PLAN COMMISSION

Wednesday, December 13, 2023 – 6:30 PM

From: Administrator/Staff
 To: Plan Commission
 Re: Public Hearing on a Conditional Use Application submitted by Utschig Inc on behalf of Last Time Realty LLC for a proposed heavy vehicle sales and rental development located adjacent to the west of 2615 West American Dr, specifically described as Tax ID #006-0341-02.

Plan Commission review & recommendation on a Site Plan Application submitted by Utschig Inc on behalf of Last Time Realty LLC for a proposed heavy vehicle sales and rental development located adjacent to the west of 2615 West American Dr, specifically described as Tax ID #006-0341-02.

NORTH ELEVATION
 1/8" = 1'-0"

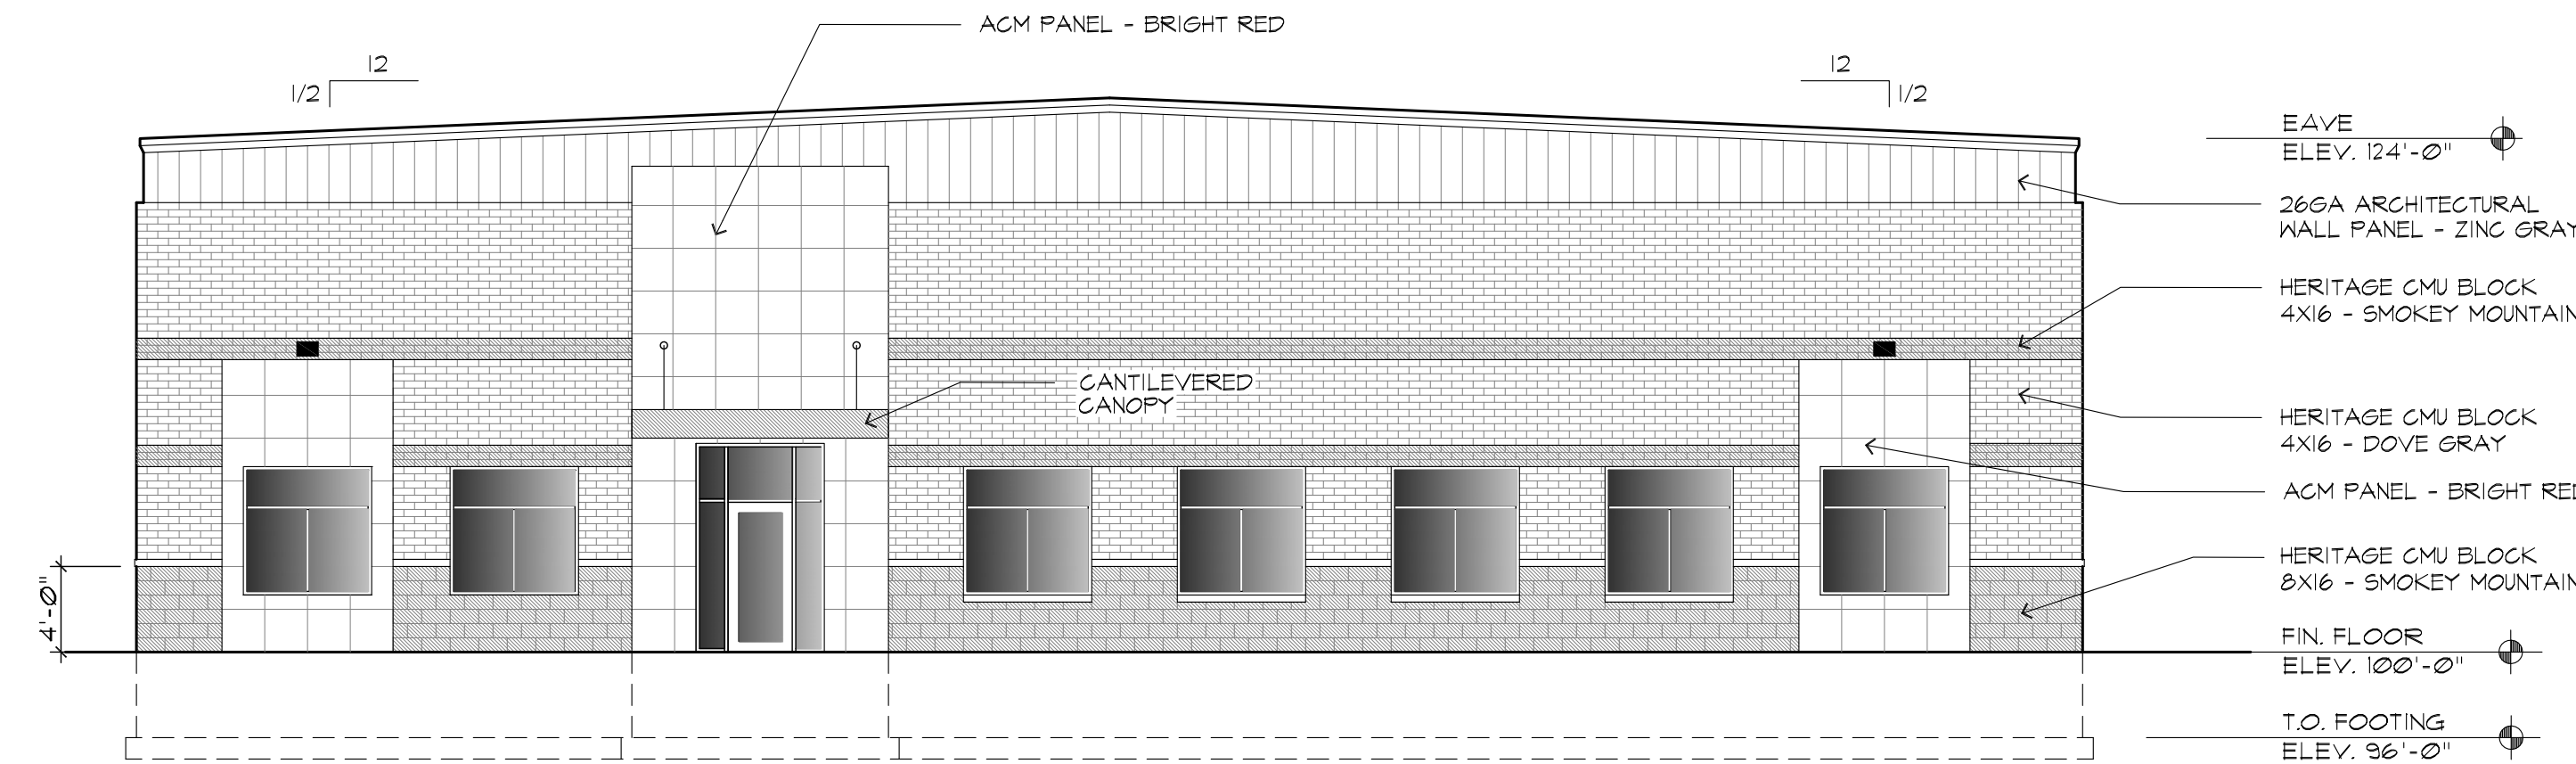
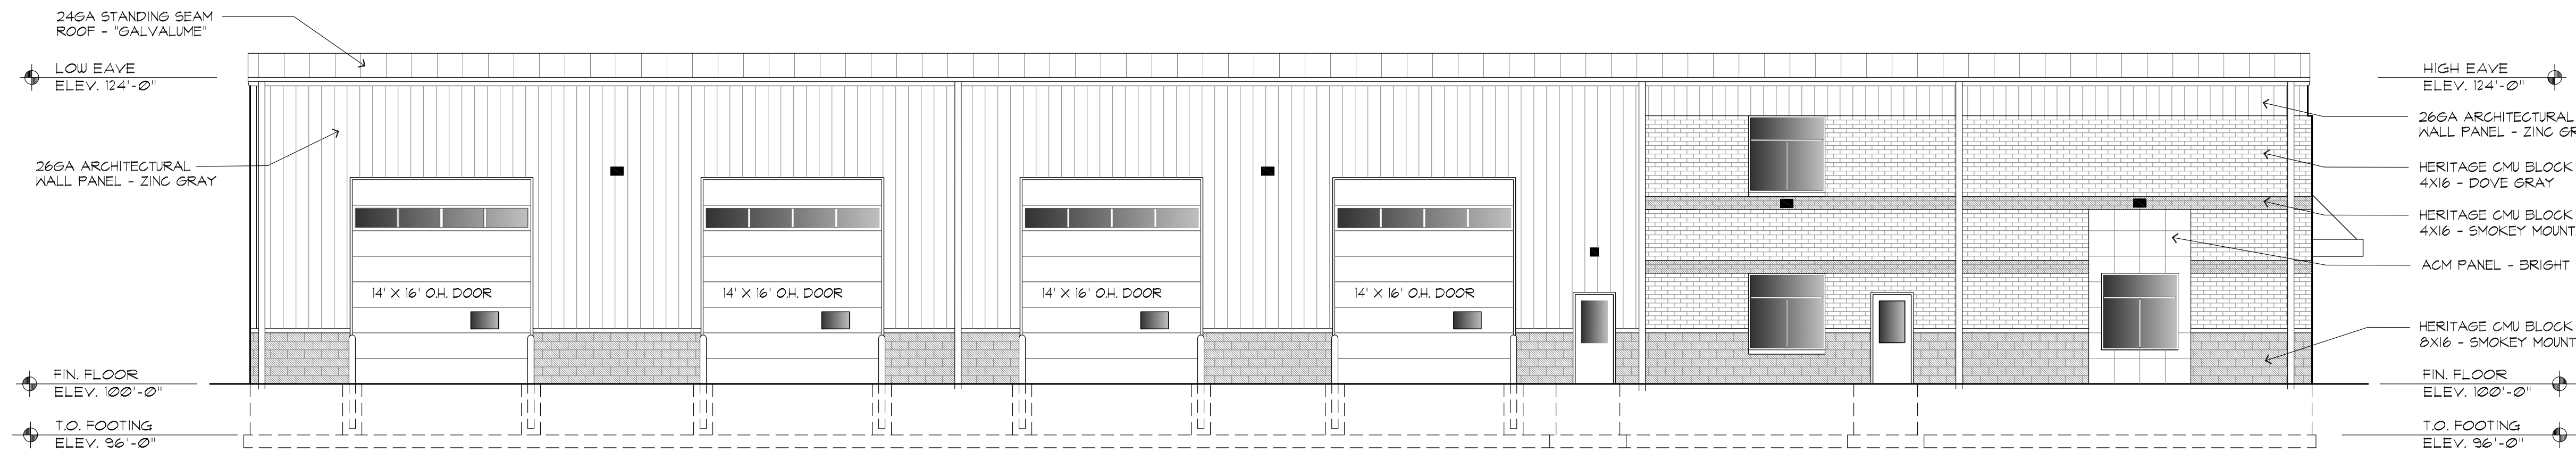
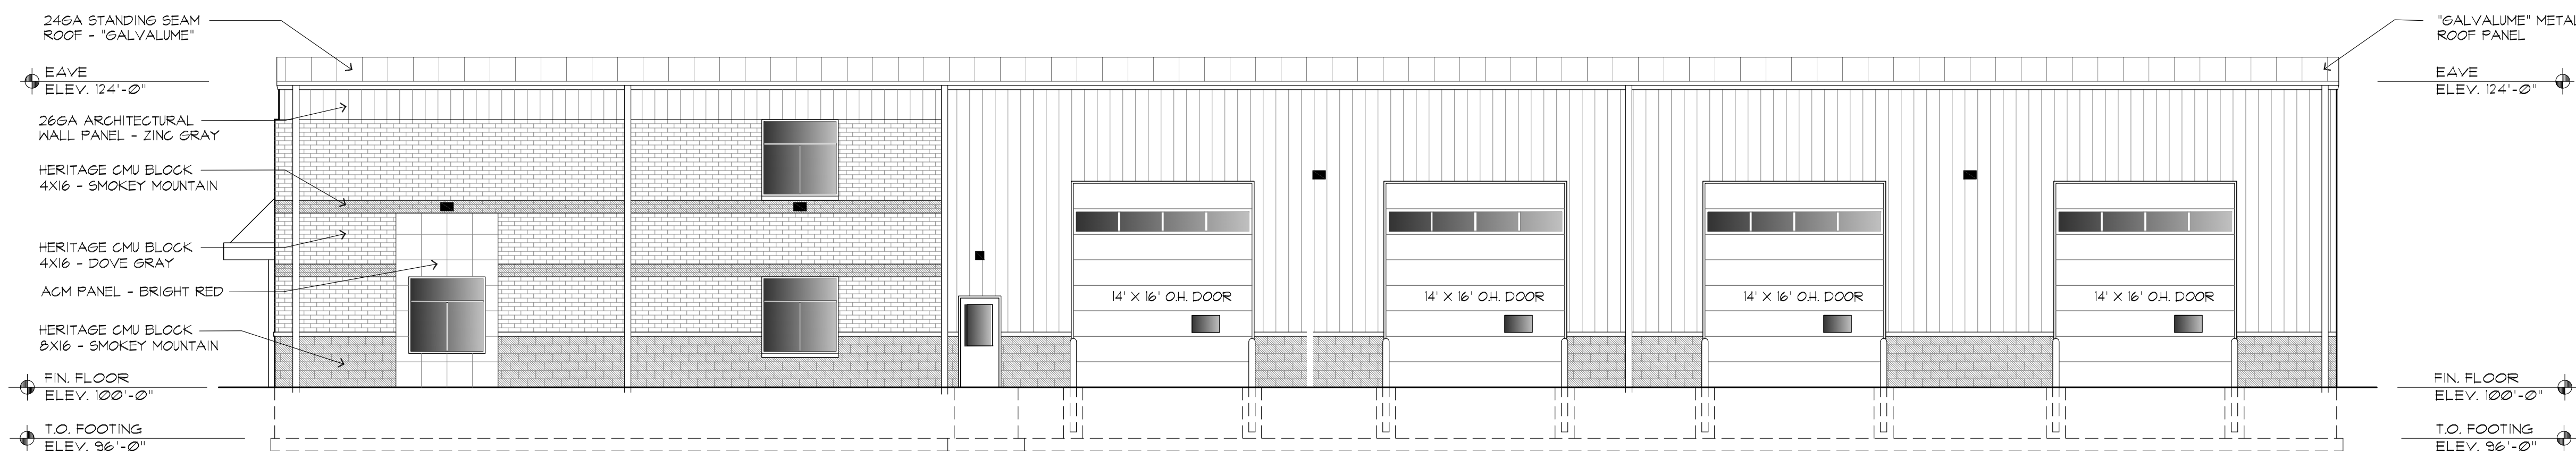
Applicant is requesting the Town to approve Aluminum Composite Material (ACM) wall panel as an “acceptable exterior building material”, and a waiver/modification to the 75% “acceptable exterior building materials” requirement.

Applicant is requesting a waiver/modification to the minimum 78 Solar Reflective Index (SRI) requirement for roofing material.

- Approving Aluminum Composite Material (ACM) wall panel as an “acceptable exterior building material”; and
- Denying request for waiver/modification to the 75% “acceptable exterior building materials” requirement due to property being in the Tier 1 development zone and high level of visibility from USH 10 and West American Dr. Extensive consideration of these requirements occurred during preparation/adoption of the Site Plan Review code amendments and Town Comprehensive Plan in 2022/2023.

Staff recommends denying waiver/modification request.

C2.0

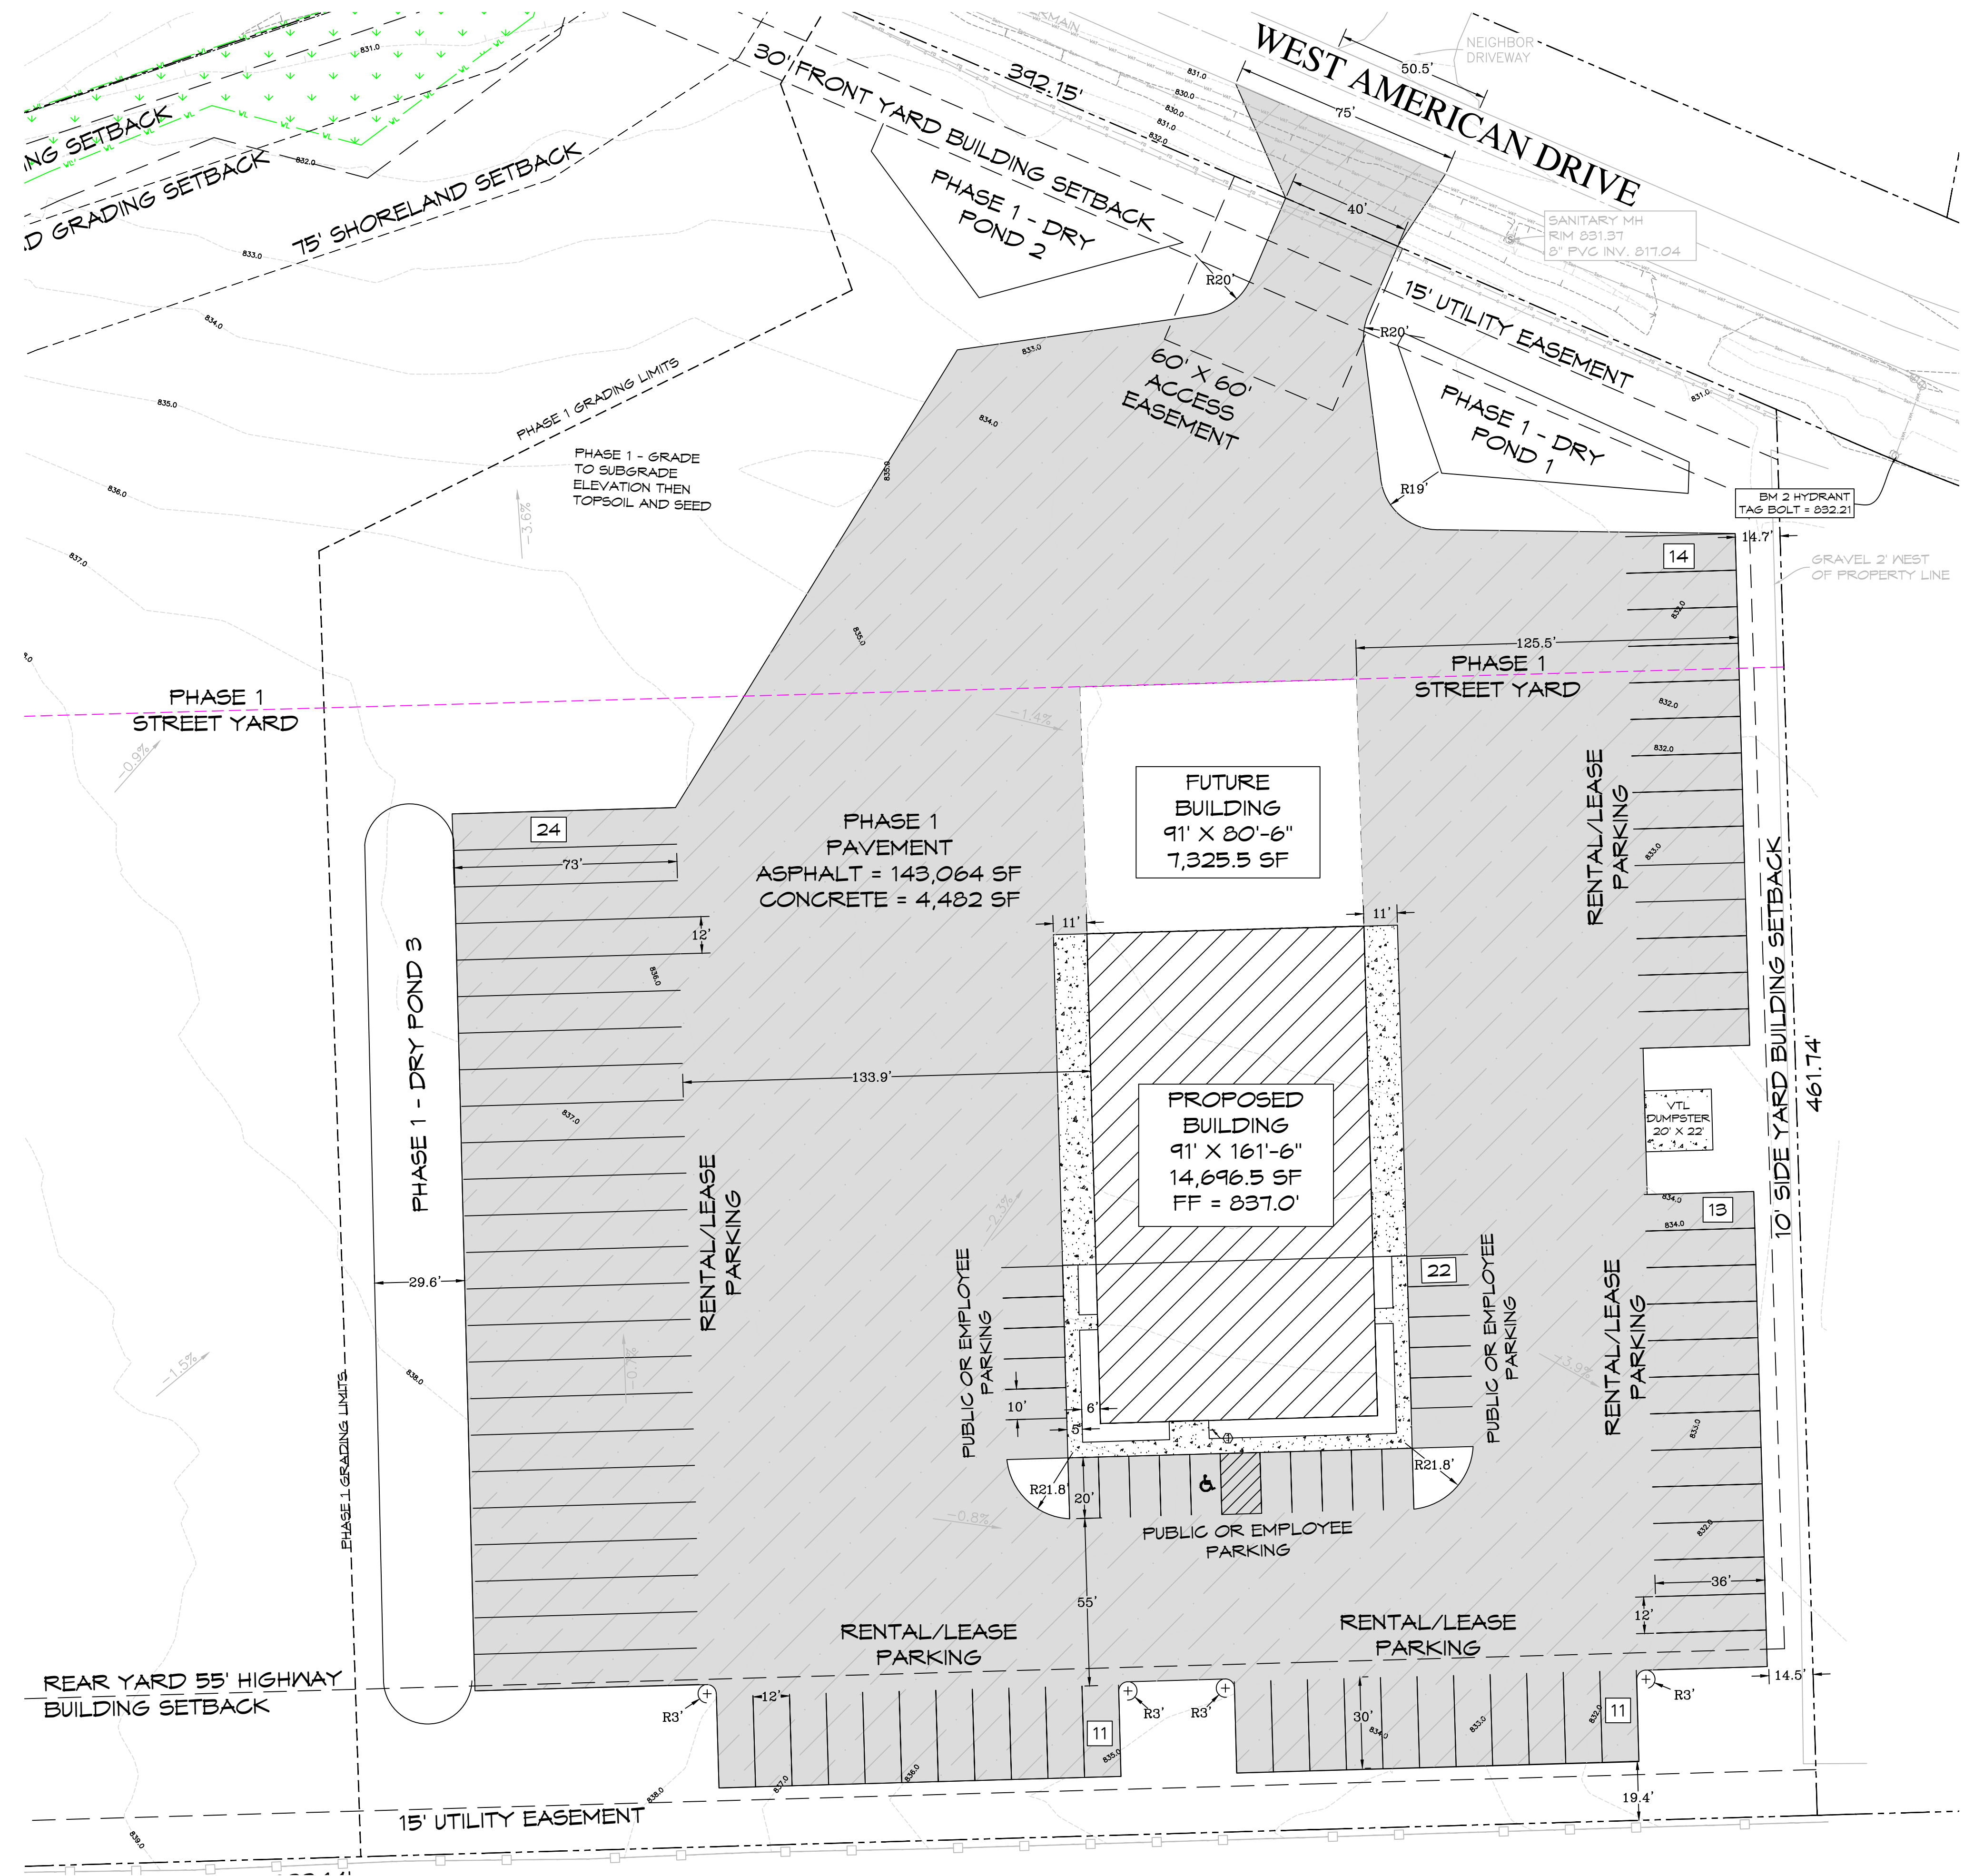
Rental/lease parking is proposed approximately 15 ft. +/- from the east property line and approximately 19 ft. +/- from the south property line. **It is staff's opinion that the parking area for rental/lease vehicles would not be considered an "outdoor display or other activity area", and such parking area would not be subject to the 25 ft. setback requirement per Sec. 9.08-291. If the Plan Commission/Town Board disagrees with this interpretation, the Town may require all parking to be located a minimum of 25 ft. from the property lines.**

Applicant is requesting a waiver/modification to allow a driveway exceeding maximum driveway width requirements.

Applicant is requesting a waiver/modification to allow outside storage of rental/lease trucks and trailers in the street yards adjacent to both U.S. Highway 10 and West American Drive.

Staff recommends granting the waiver/modification and allowing driveway as proposed.
